ADDENDUM NO. 1 June 6th, 2024

PROJECT: ANSON INDEPENDENT SCHOOL DISTRICT VOC. TECH RENOVATION

The following changes and/or additions shall be made to the Plans, Specifications, and Contract Documents for the above referenced project. Bidder shall acknowledge receipt of this Addendum on the Construction Costs Form.

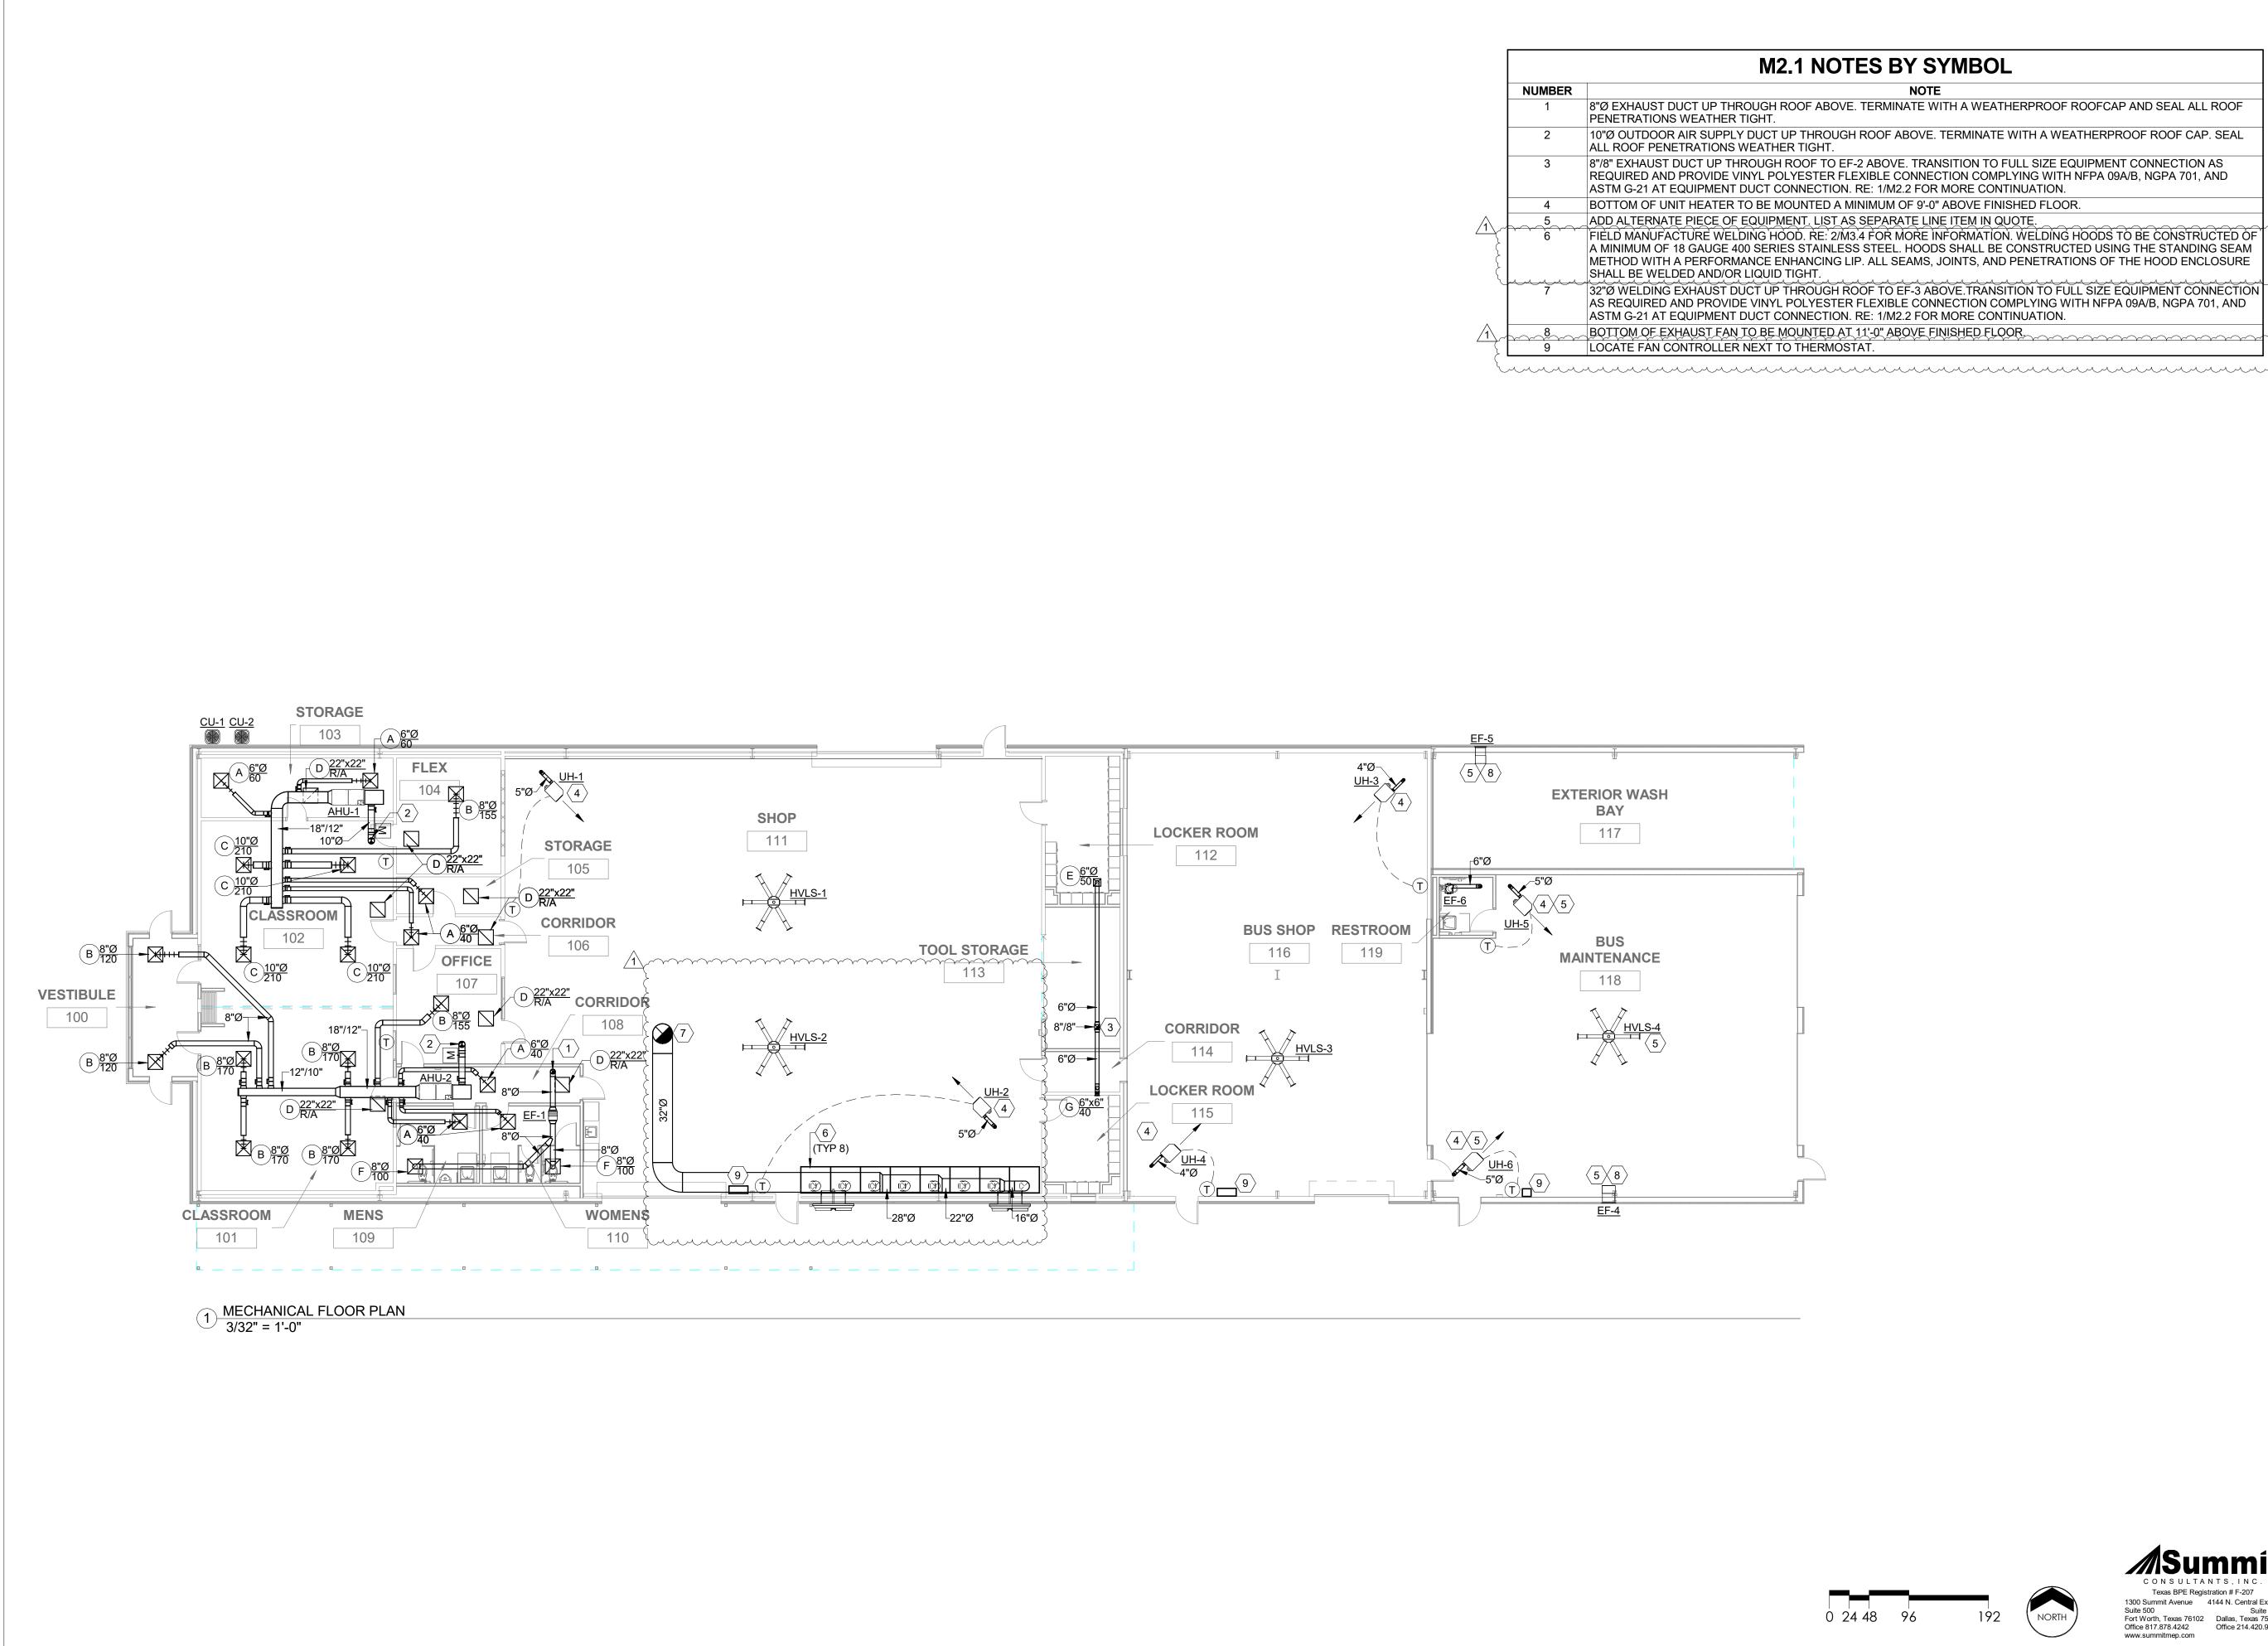
Item #D10	Sheet M0.1 – REPLACE sheet with attached sheet M0.1 dated 06-0602024. UPDATED mechanical schedules and notes.		
Item #D11	Sheet M2.1 – REPLACE sheet with attached sheet M2.1 dated 06-0602024. UPDATED mechanical floor plan for welding hood ductwork and notes.

1 MECHANICAL ROOF PLAN 3/32" = 1'-0"

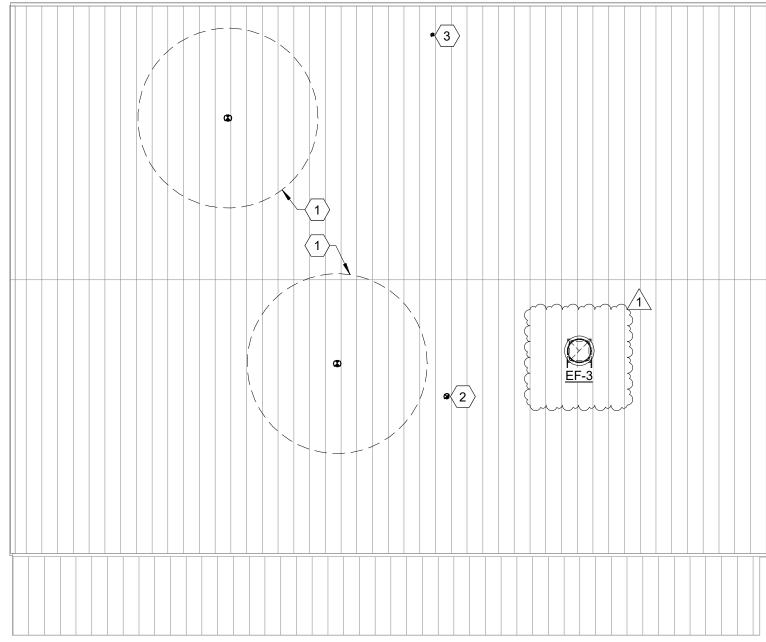
Item #D12	Sheet M2.2 – REPLACE sheet with attached sheet M2.2 dated 06-0602024. UPDATED mechanical roof plan.		
Item #D13	Sheet M3.1 – REPLACE sheet with attached sheet M3.1 dated 06-0602024. REMOVED detail 4.
